SYMBOL	ZONE	REVISIONS: DESCRIPTION	DATE	BY
	C-5	REVISED IN ACCORDANCE WITH AMENDMENT NO. 0002	18 APR 03

HARTWELL MAJOR REHABILITATION - PHASE 2
HARTWELL DAM AND LAKE
SWITCHYARD UPGRADE
DRAWING INDEX
SHEET 1
SAVANNAH RIVER GEORGIA AND S. CAROLINA

HARTWELL MAJOR REHABILITATION - PHASE 2
HARTWELL DAM AND LAKE
SWITCHYARD UPGRADE

BAY THREE
SECTION B - B
DRAWING E-41

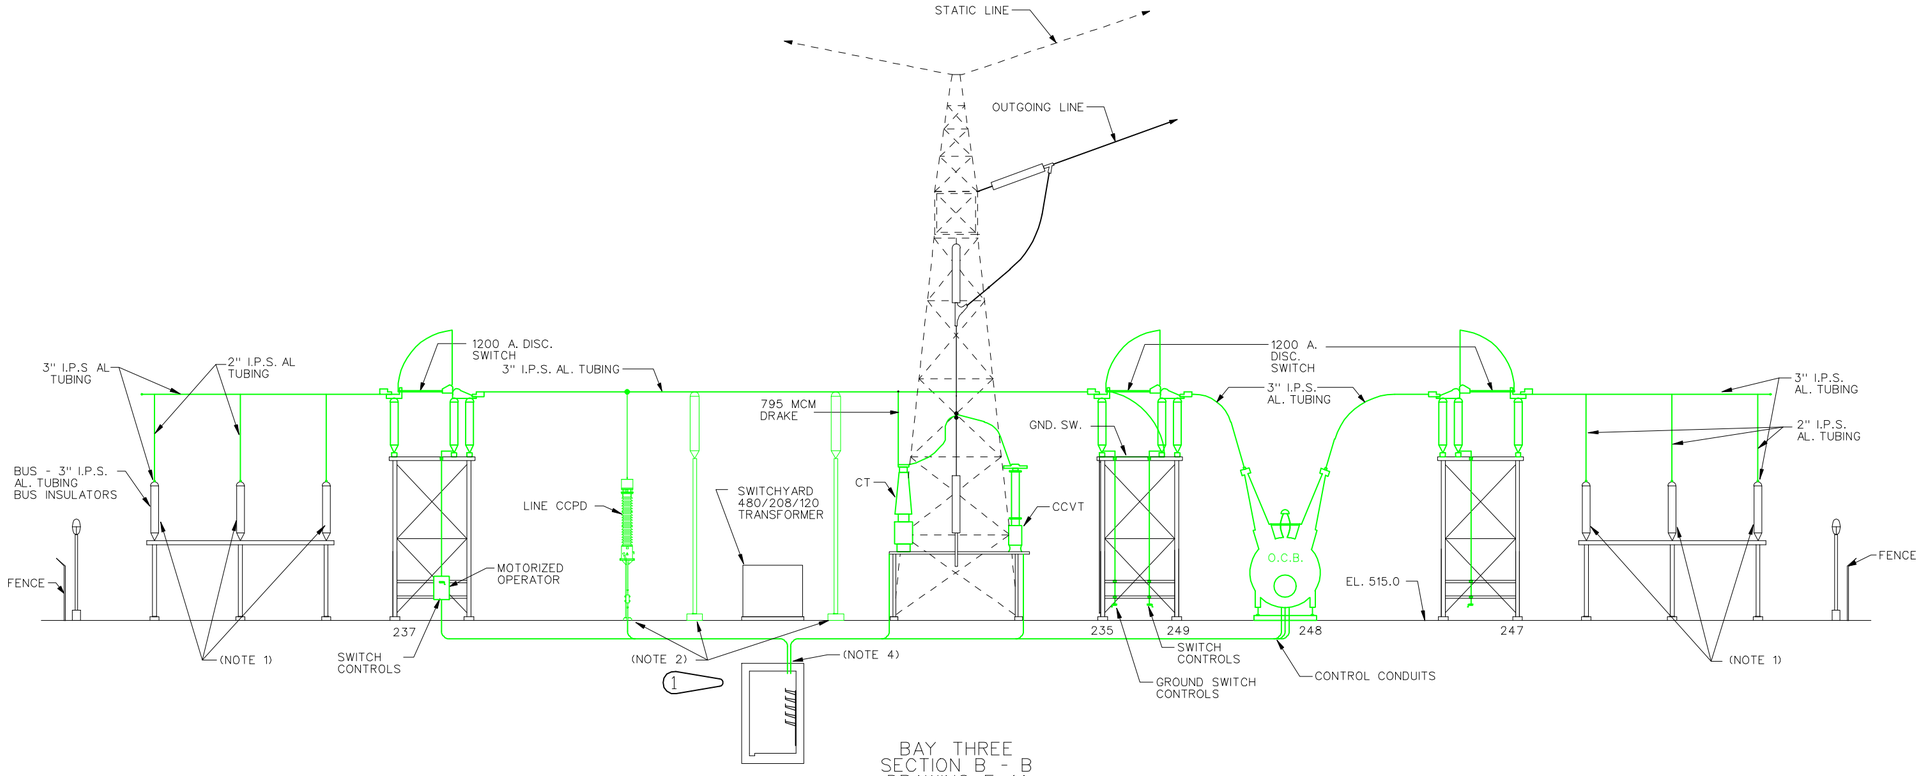
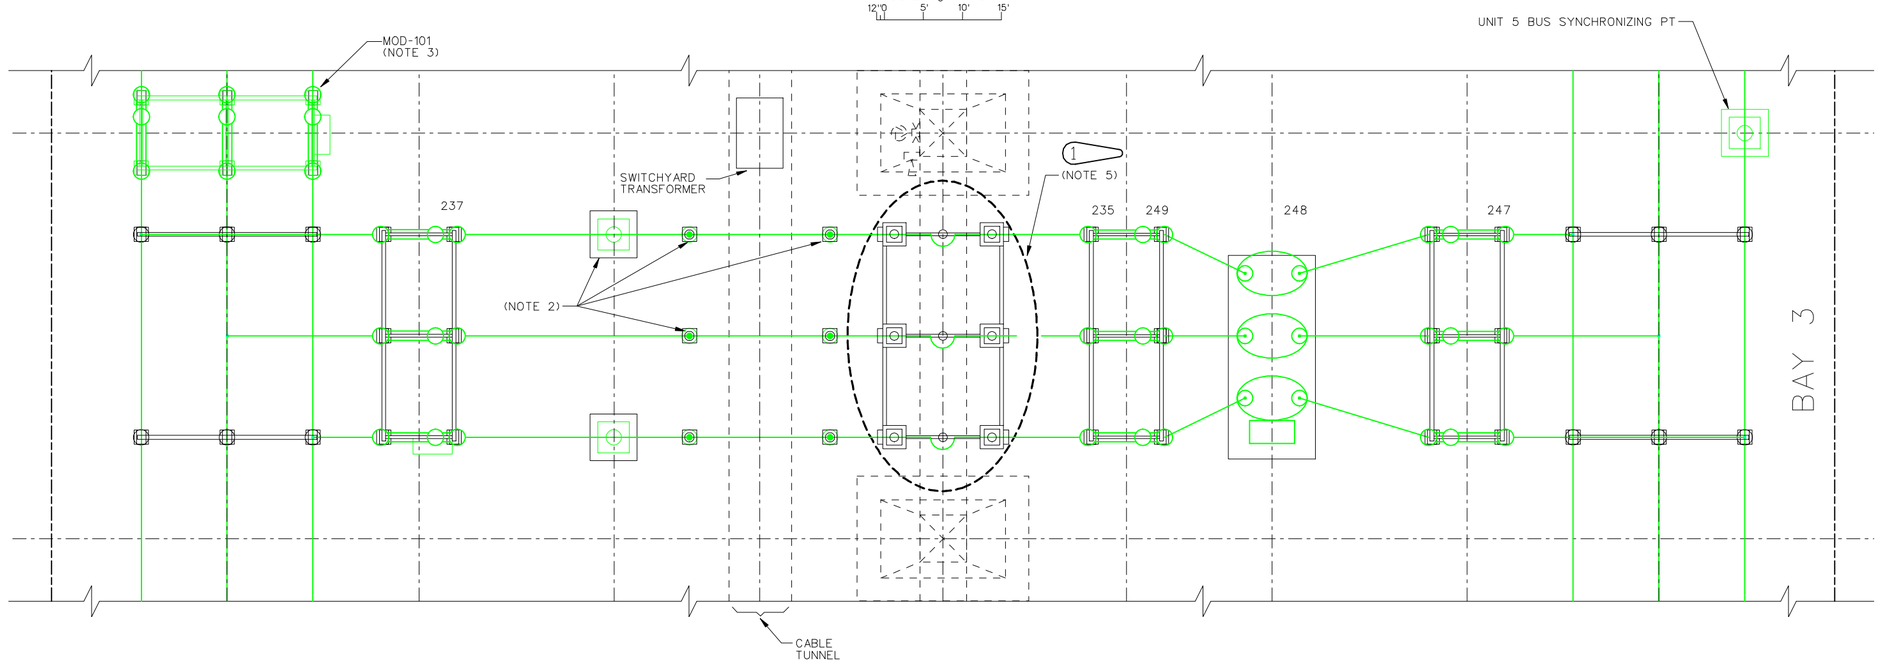
1. EXISTING BUS INSULATORS SHALL BE CLEANED AND TESTED AS PER SECTION 16050 AND REUSED.
2. EXISTING CONCRETE FOOTINGS SHALL BE REMOVED FOR EQUIPMENT BEING REMOVED OR RELOCATED.
3. MOD-101 SHALL BE REMOVED WITH ALL CONTROLS, SUPPORTS, FOOTINGS, AND CABLES.
4. EXISTINIG CONDUITS BETWEEN TUNNEL AND EXISTING EQUIPMENT SHALL BE REMOVED AND NEW CONDUITS INSTALLED BETWEEN EQUIPMENT AND TUNNEL. EXISTING CONDUITS SHALL BE DRILLED OUT OF TUNNEL ROOF, NEW CONDUITS INSTALLED AND SEALED WITH POR-CRAX HP AS PER DETAIL DRAWING E-54
